Re: Strata Energy, Inc., Ross In-Situ Recovery Project
Source Materials License SUA-1601, Docket No. 040-09091
Request for Additional Information, LC 9.5, 2018 Annual Revised Financial Assurance Estimate

RAI 1

RAI 2

RAI 3:

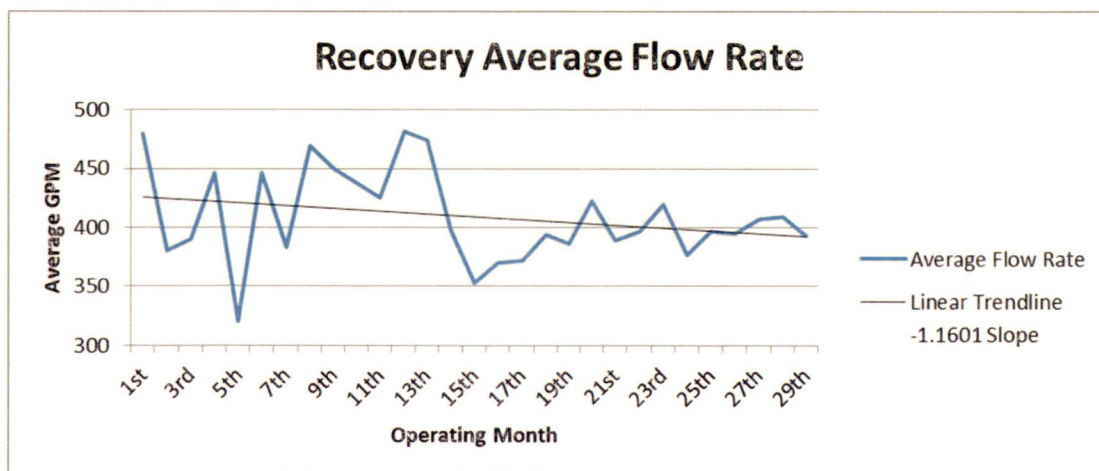
Please provide a detailed basis for the adjustment in flare factor. Alternatively, please revise the surety calculations to use the previously approved flare factor of 1.58 for the Ross ISR Project.

In preparing the 2018 surety update, Strata evaluated the impact of site-specific injection and recovery flow rates, well placement and wellfield geometry in Mine Units 1 and 2. The results of this evaluation support the lower flare factor of 1.44. These aspects were identified in the numeric modeling provided with the license application as the most sensitive inputs¹. As required in Appendix A, Criterion 9, Strata
